Product Change Notice (PCN)

PCN Number: **PCN-0454916R-01**

Product(s) Affected: *PJ-085H*

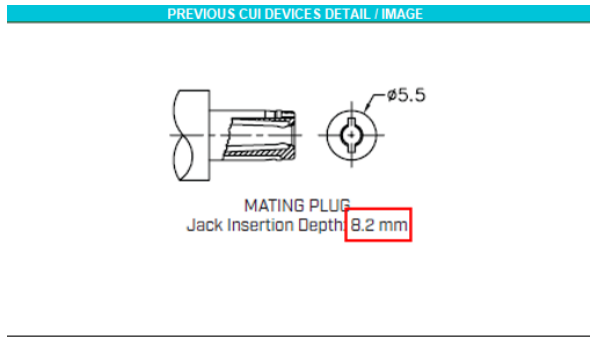
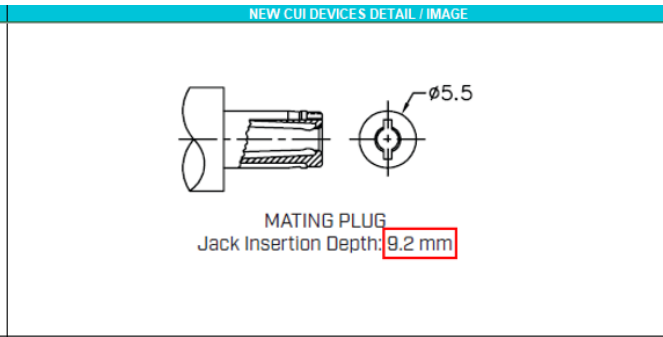
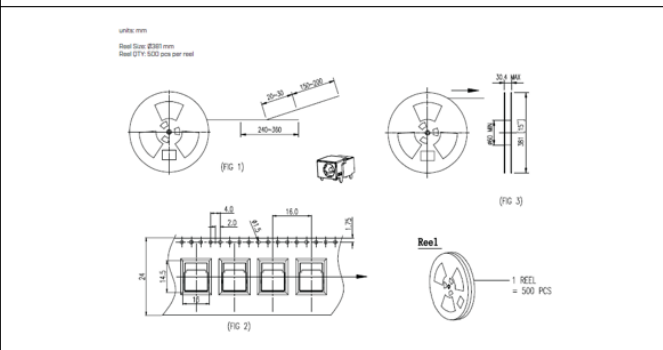
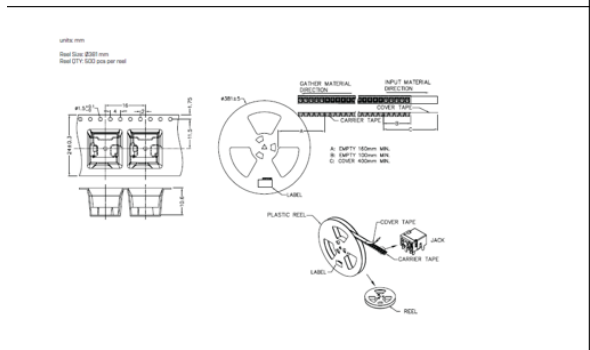
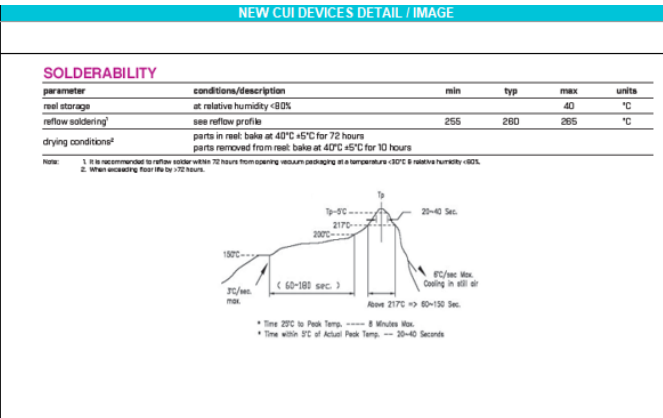
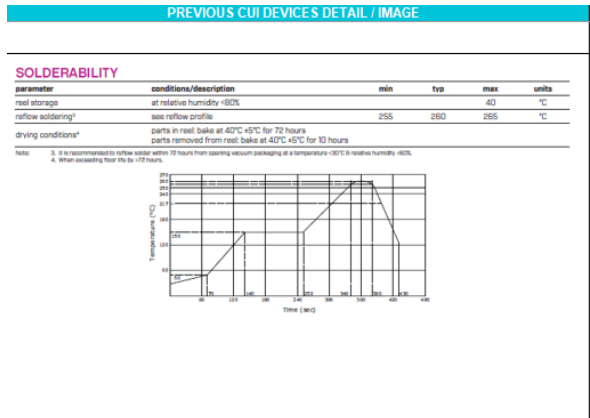
Description of Change: *Minor Housing and footprint differences. Material Change on the housing and terminals. See image Below*

MATERIAL	PLATING
center pin	copper	nickel
terminal 1	brass	silver
terminal 2	copper alloy	silver
terminal 3	brass	silver
terminal 4	copper alloy	silver
shield A	brass	nickel
shield B	stainless steel	
insulator	PA10T

DESCRIPTION	MATERIAL	PLATING
center pin	brass	nickel
terminal 1	brass	silver
terminal 2	phosphor bronze	silver
terminal 3	brass	silver
terminal 4	phosphor bronze	silver
shield A	brass	nickel
shield B	stainless steel	clean
housing	PA10T (UL94V-D)	black
